City of Ukiah, CA

Design Review Board

MINUTES

October 9, 2014

3 - South Orchard project

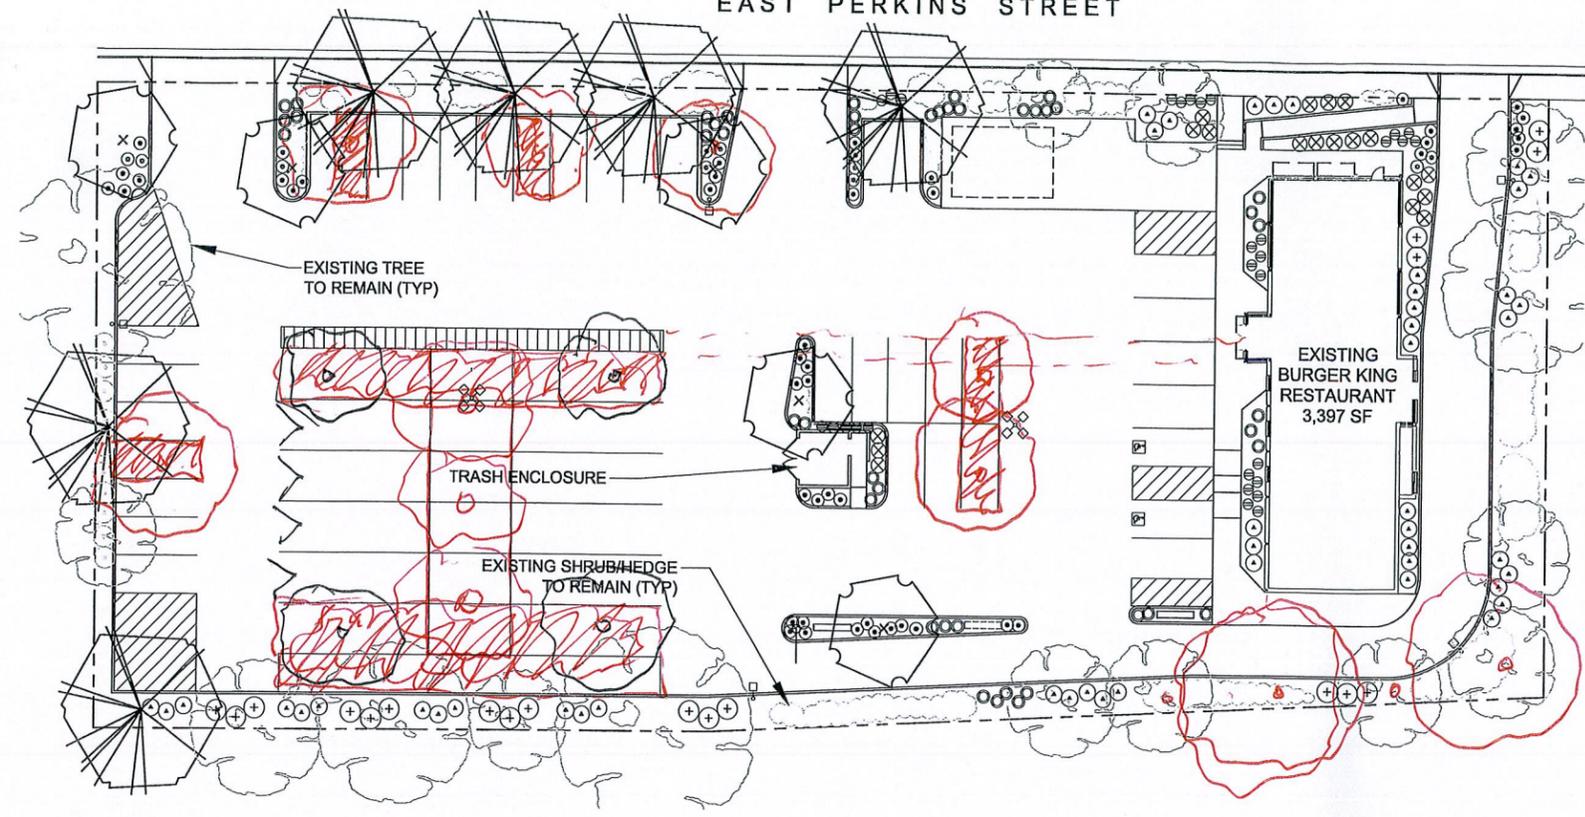
Totally supportive of the venture, we need more local industry. Unsure about the food service and wool processing together, but I assume Public Health will comment on that.

"Landscape plan" isn't really a landscape plan, it is an assessment of what is on site now. Would like to see an actual plan with the proposed tree screening noted on plan. I am fine with the proposed Live Oak, but the California Nutmeg (*Torreya californica*) is not a good choice for the valley floor, if you could even find it in a container in the first place. And the #5 containers being proposed are not suitable, #15 need to be used. Others suitable trees can be found on the City of Ukiah recommended tree lists (parking or residential list). Maybe Staff can provide Applicant with these lists?

I wonder if the Water Efficient Landscape Ordinance comes into play with this project. If is a commercially zoned property applying for a remodel permit, it would be required to replace the expansive lawn. Not sure how this plays out with the mixed use zoning. But either way, less lawn needs to a component of approval.

PROJECT #: 14-891
 DATE: 06-20-14
 FACADE RENOVATION DOCUMENTS
 BURGER KING RESTAURANT
 711 EAST PERKINS STREET
 UKIAH, CA 95422
 A.C.N. 179-081-34-00 & 179-081-04-00

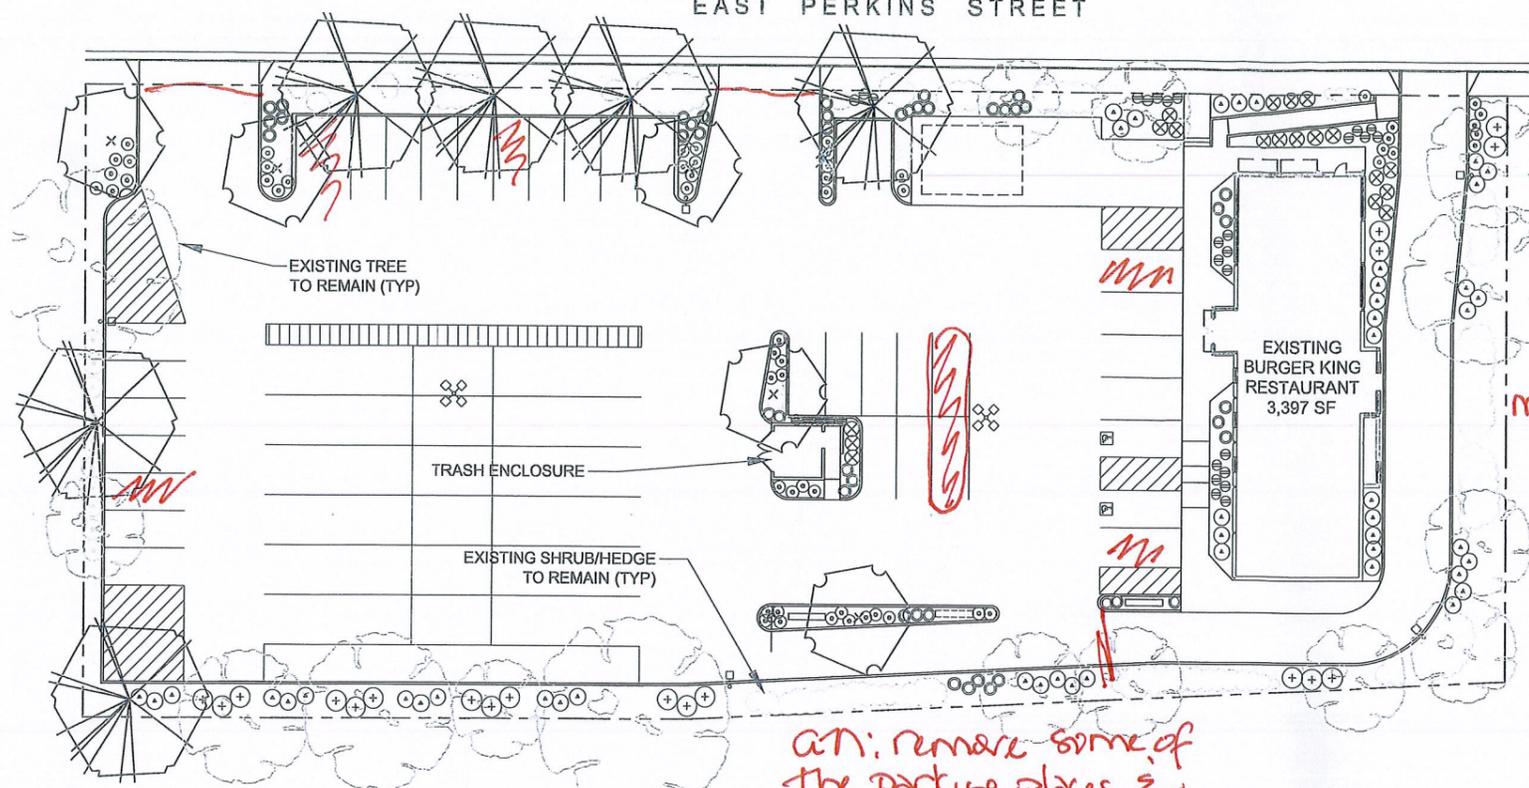
ATTN: remove some of the parking places & plant trees, showed sketch needs to make more of an attempt at shading of parking lot
